Special Bulletin

SP15-325

BI-FOLD DOOR IMPROVEMENTS Prevost vehicles

On the vehicles affected by this bulletin, perform various improvements on the bi-fold door mechanism.

Figure 2 Torque reference, fore door links

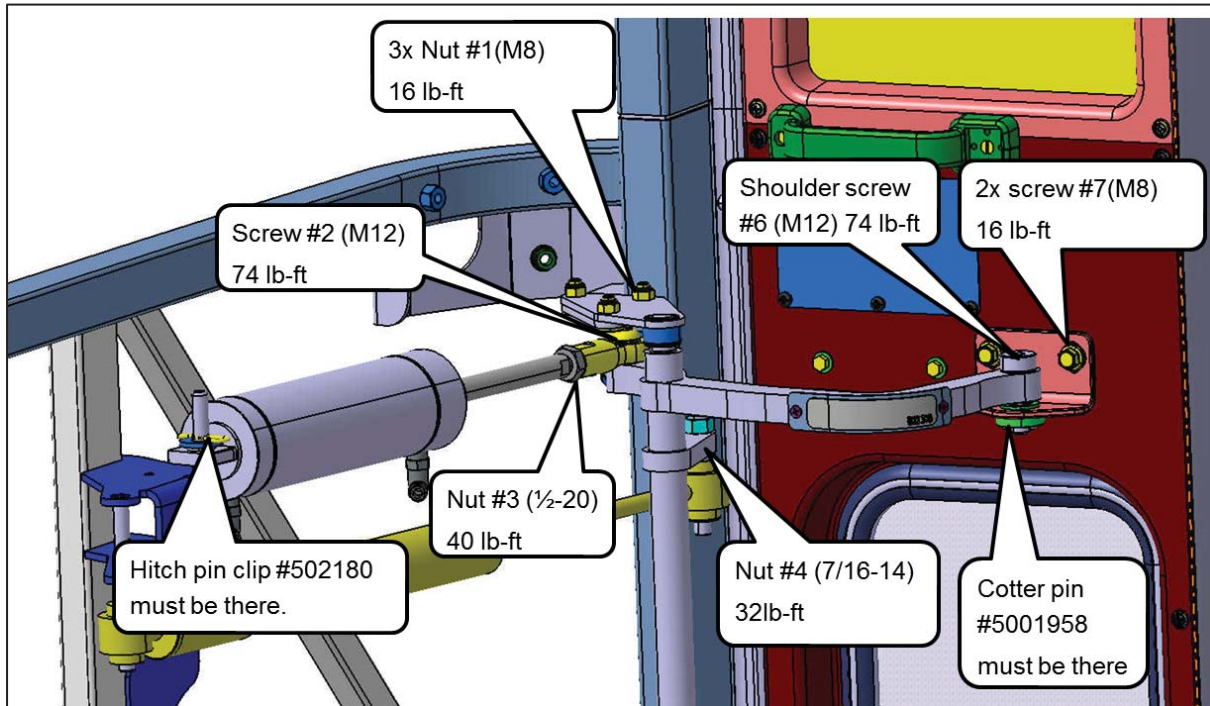
Items # 6, fig. 2 and #11, fig. 3:

Change the existing screw for# 2800984.(Qty:4) Tighten to **74 lbf-ft.** Apply torque seal.

10) Finally, tighten each item shown in Torque Reference Figures 2, 3 and 4, with the exception of the items already tightened so far in the bulletin. Apply torque seal.

Figure 5

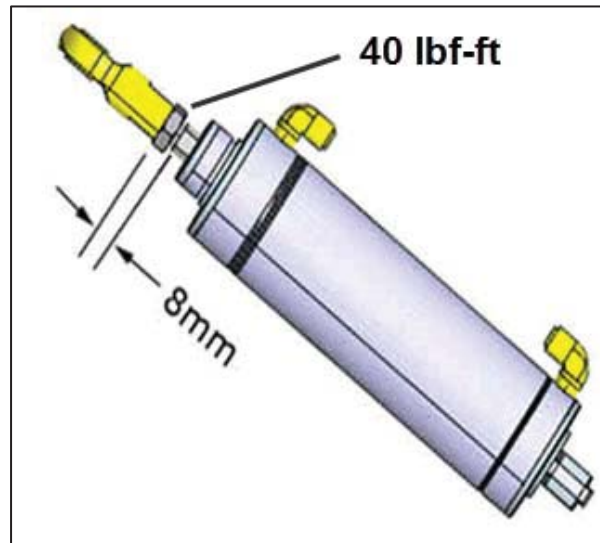
- 1) On fore and aft cylinder, adjust rod end to dimension shown in fig. 5.
- 2) On fore and aft air cylinders, tighten rod end nut to **40 lbf-ft**. Apply torque seal.
(#3,fig. 2) ; (#10 fig. 3)

Figure 6

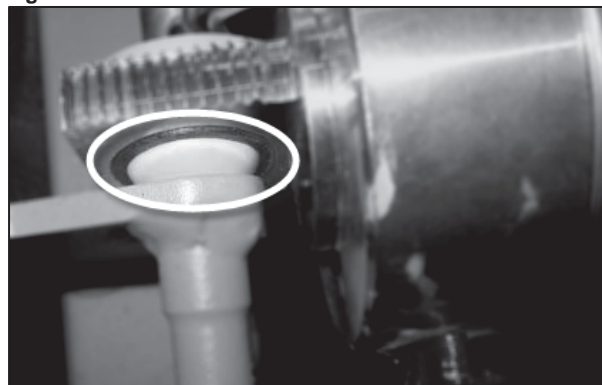
- 3) Remove the fore cylinder completely. Reserve hardware for re-assembly.
- 4) Inspect the cylinder bushing for any signs of looseness or damage. Replace with #642228 if required. (Fig. 6)

Figure 7

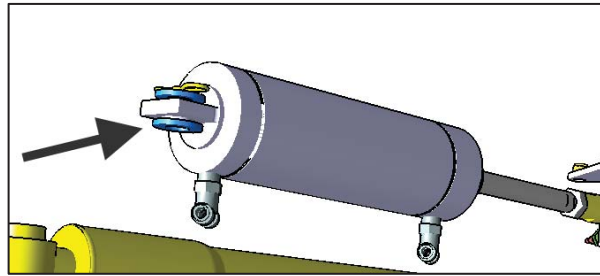
- 5) Re-assemble cylinder frame side anchor adding a washer under the anchor. (Arrow, Fig. 7)

Figure 8

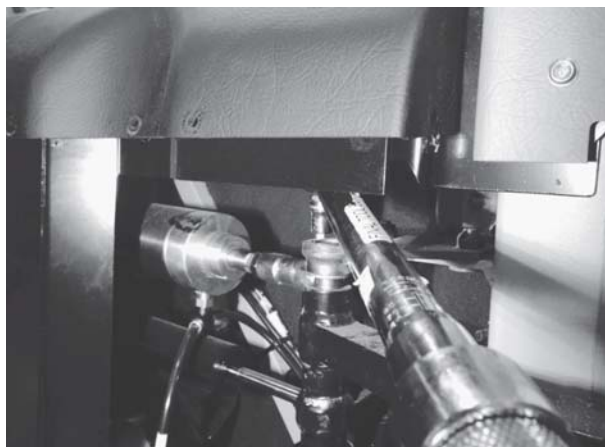
- 6) Tighten shoulder screw on door side to **74 lbf-ft.** (fig. 8 & #2, fig. 2).

Apply torque seal.

Figure 9

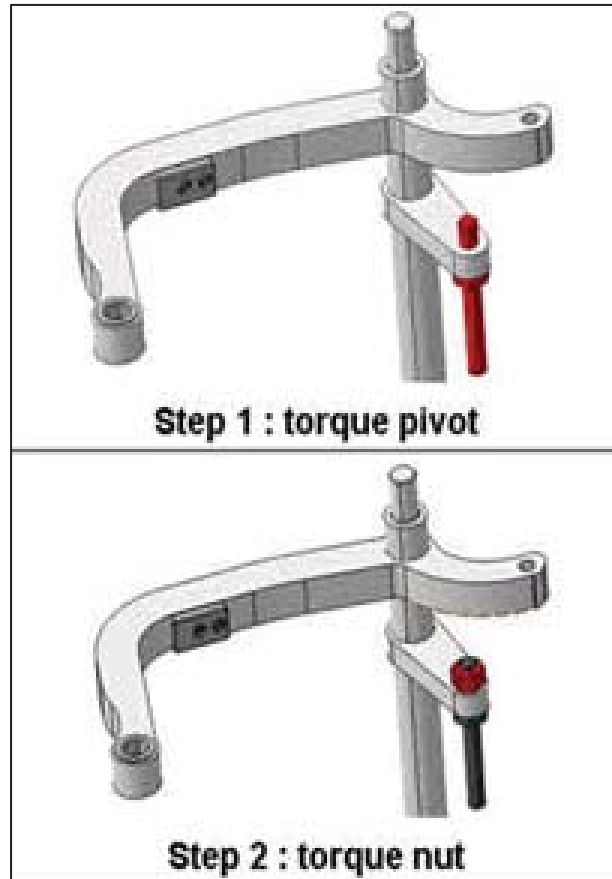
- 7) On the damper pivot, loosen the assembly and re-tighten in the appropriate sequence. (Fig. 9)

Tighten both items to **32 lbf-ft.** (#4, fig. 2)
Apply torque seal.

Figure 10

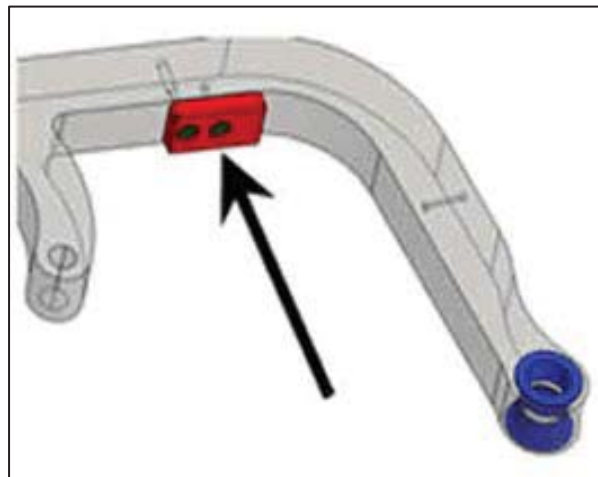
- 8) Inspect the door stopper to make sure it is oriented properly. (Fig. 10)

(Long edge towards the curve of the arm)
